SERVICE BULLETIN

PURPOSE : INFORMATION	ISSUE NO. : MSB-09E54-003A	DATE : 2009-10-05
SUBJECT : TROUBLESHOOTING FOR SECURITY ALARM SYSTEM	<div> <div><MODEL></div> <div>(EUR/RUSSIA)</div> <div>OUTLANDER</div> <div>(GS45X)(CW0W)</div> </div> <div> <div><M/Y></div> <div>10</div> </div>	
GROUP : CHASSIS ELECTRICAL

Regarding the troubleshooting of the security alarm sensors (ultrasonic sensor and tilt sensor), there have been some errors and missing items. This Service Bulletin contains the correct information.

Attached sheet 5 (3,4/5)

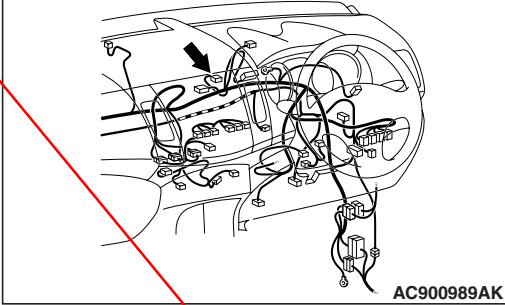
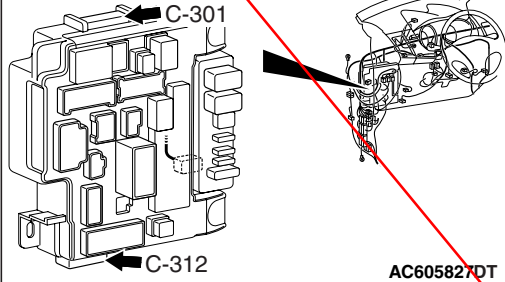
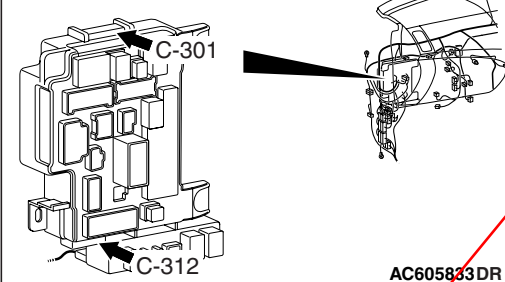
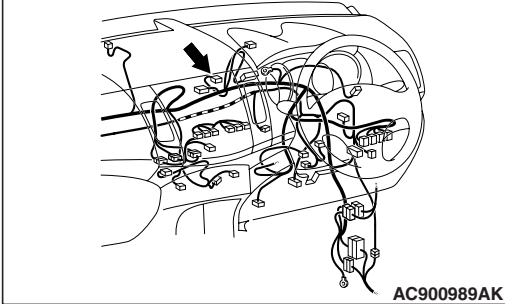
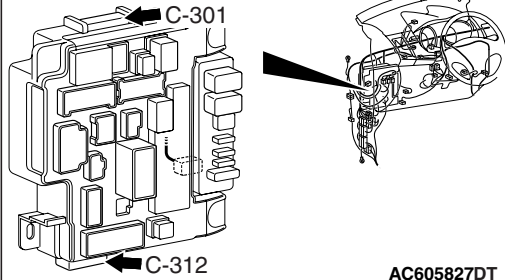
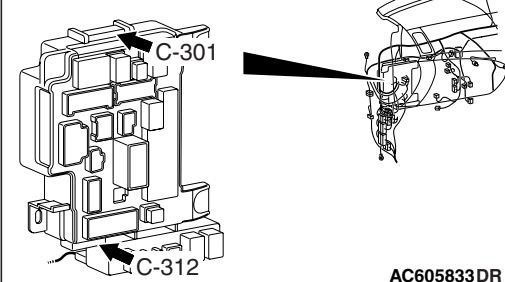
If the activated security alarm siren sounds even though no faulty operation is made, the security alarm siren may not be able to receive the signal from the ETACS-ECU via the LIN cutoff control unit.

<Incorrect>

<Correct>

NOTE: The security alarm siren may be sounding by false alarm. Investigate what kind of situation the security alarm siren sounded under. Check if there was any condition that caused false alarm.

DIAGNOSIS PROCEDURE**STEP 1. Vehicle status check when security alarm siren is sounding**

(1) Since it is suspected that the security alarm ~~Siren~~ ^{<Deleted>} has sounded accidentally, investigate whether the vehicle is under the situation below. Repair if an abnormality is found.

- The windows and sunroof are open.
- Some moving accessories are fitted in the vehicle.
- The interior equipment has been modified before a malfunction occurs. ^{<Incorrect>}

(2) Set the sensitivity level of security alarm ~~Siren~~ ^{<Deleted>} to Level 4 by using the customisation function.

(3) Check if the security alarm siren sounds during the status of "Ready to be triggered" even though no faulty operation is made.
